Kiggavik Project Final Environmental Impact Statement

Tier 3 Technical Appendix 20: Mine Site Airstrip Report

KIGGAVIK PROJECT MINE SITE AIRSTRIP REPORT

Figure 1.0-2 on the following page shows the various project elements discussed within this Report and the other Reports listed above.

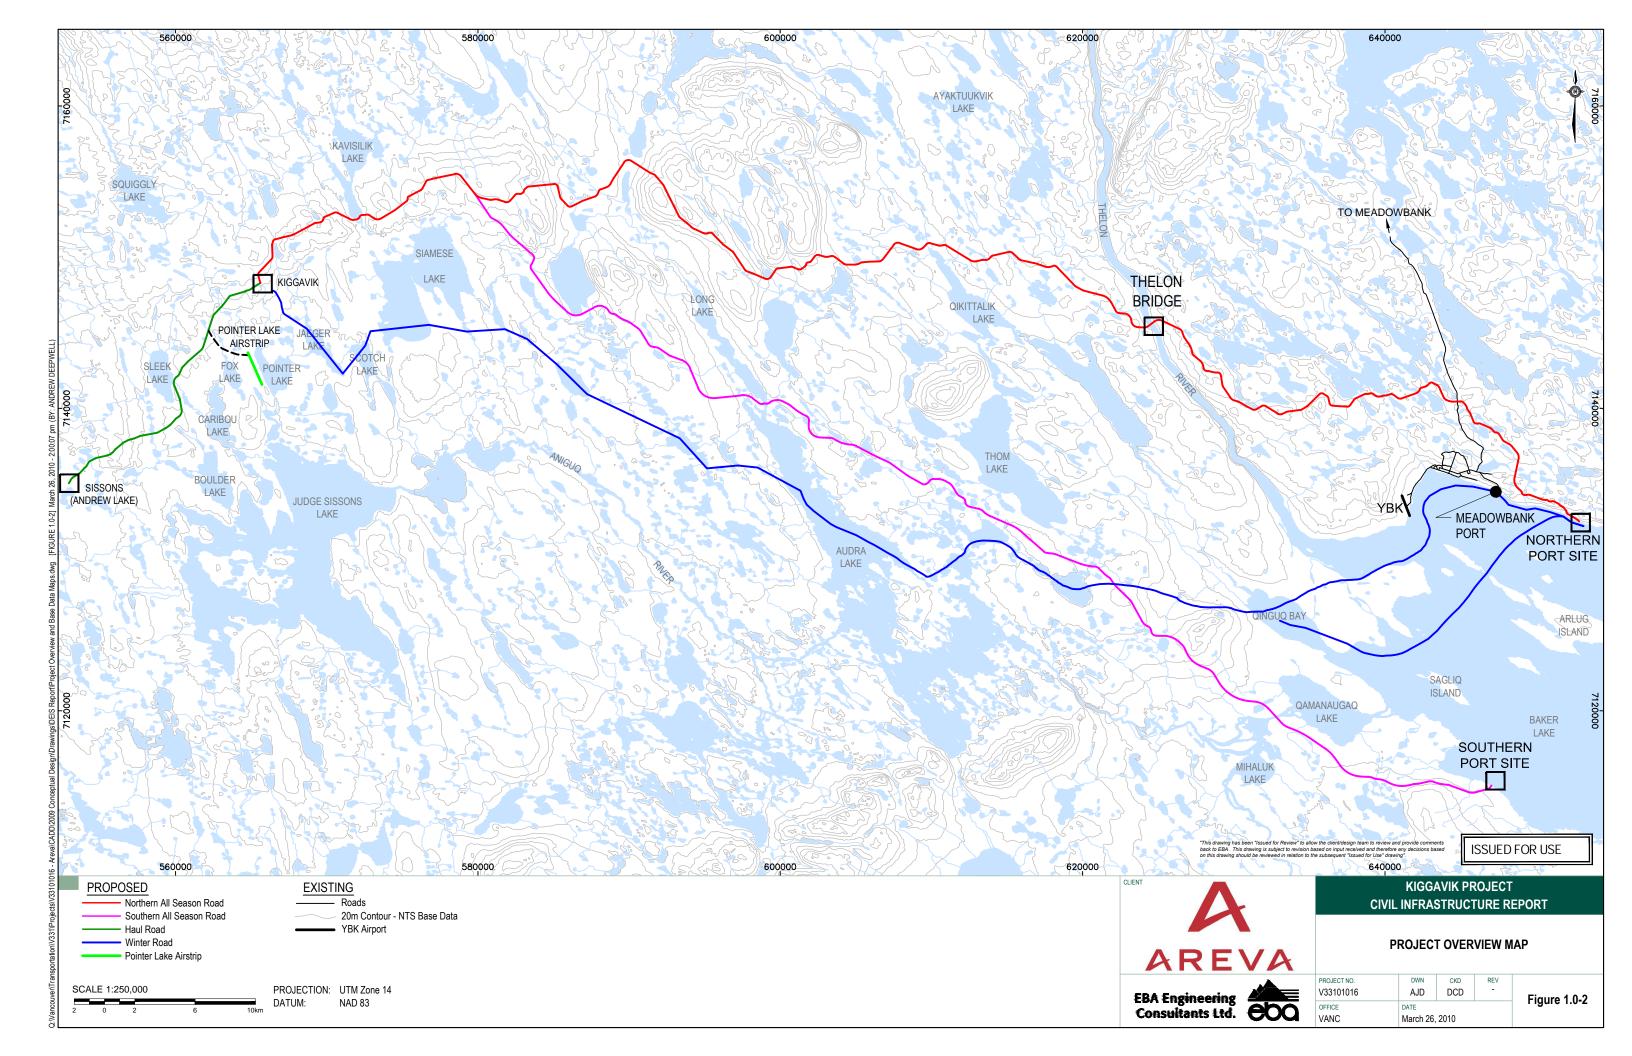
Figure 1.0-2 is outdated and does not reflect the currently envisioned access roads. For an updated project overview map, refer to Tier 2, Volume 2 Project Description, Figure 2.3-1.
